# Paradise Dam Upgrade Options Assessment

Independent Design, Cost and  
Risk Review

**Building Queensland**

Reference: 507854

Figure 3 FN-plot for upgrade options (from GHD 2020)

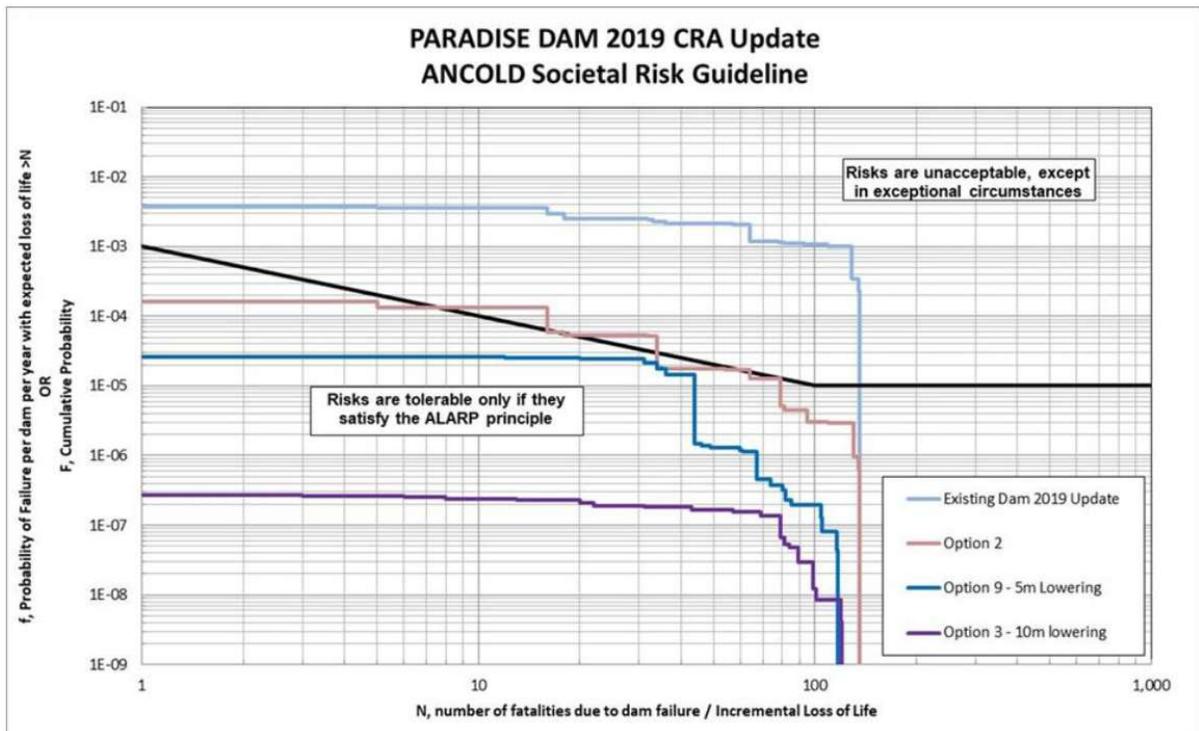
- g) The latest FN-plots (GHD 2020) for the options are shown below.

Note, in Figure 3, Option 1 is labelled as Option 2, and Option 2 is labelled as Option 9.
